Application: D02-02-26-0012 (Minor ZBLA) and D07-
12-26-0014 (SPC)

TREE CONSERVATION REPORT ADDENDUM 4.0

71 Russell Ave

Date of Report: August 25, 2026

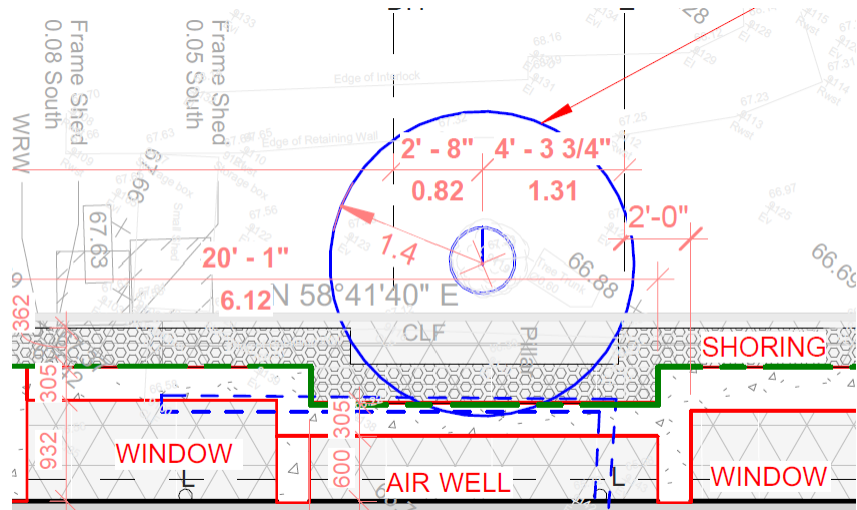
o The City cannot approve a document requiring the neighbour (69 Russell Ave) to sign a liability waiver

associated with retention of their tree. This is not supported by the City's Tree Protection By-law (No. 2020-340). This needs to be removed from the TCR. Outside of the requirements of the Tree Protection By-law, any agreements made between neighbours would need to be done privately.

The liability waiver was a recommendation included in the TCR as independent guidance for the property owner, irrespective of the proposed site development. The tree has outgrown its rooting space, and there is evidence throughout the adjacent property that there is significant soil instability. There is also evidence that the tree has likely not been maintained as the large branch with a significant wound hanging over the adjacent residence has not been addressed. Regardless of whether the development moves forward, this tree should be monitored and maintained by the owner to ensure public safety

The proposed development at the site will include shoring and a retaining wall that will increase soil stability, which should help to reduce the risk of tree failure brought on by soil erosion. While Dendron Forestry Services respectfully disagrees with the request to remove the recommendation for a liability waiver, we consent to its removal from the TCR to comply with the current review parameters. Please consider this statement a formal retraction of that specific recommendation.

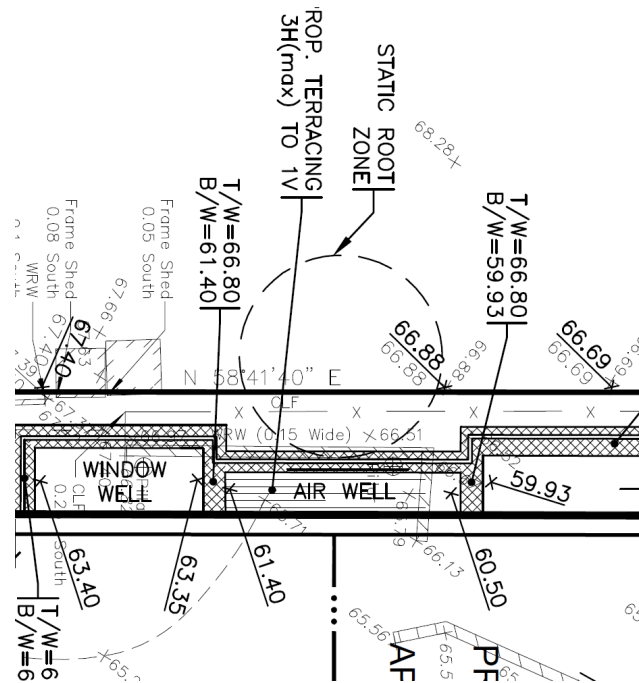
o The static root zone of a tree is defined by the International Society of Arboriculture Best Management Practices as the tree's diameter times three. For a 45cm diameter tree, the static root zone would be 1.35m. No lateral cut to a root shall be made in this area without risking instability. The TCR states the wooden structure on site was 40cm from the L bend and 90 cm to centre of the tree. The excavation to install the shoring is stated as being 20 cm closer to the tree than the wooden wall. This does not align with the ISA BMPs that suggest no roots should be cut in a tree's static root zone. The TCR needs to outline what the static root zone for this tree is and how far excavation/root pruning would need to be from the tree to avoid compromising this trees health and stability. This must align with the civil plans.

The project team has redesigned the wall to include a notch around the tree that relocated the shoring and proposed retaining wall to follow the path of the previous wooden wall, which followed the extent of the roots on the subject property immediately adjacent to the tree. The image below shows the updated site plan that includes the surveyed location of the tree and the location of the old wooden wall (extent of roots) as the dashed blue line. The green line represents the extent of excavation via shoring. This notching also demonstrates how the roots beyond the elbow of the old wall that will be severed as part of the shoring installation are outside of the static root zone, which is defined as three times the diameter of the tree. Although the diagram shows the measurement of the static root zone from the centre of the tree, the excavation is still outside of the static root zone if measured from the edge of the tree (an additional 23 cm).
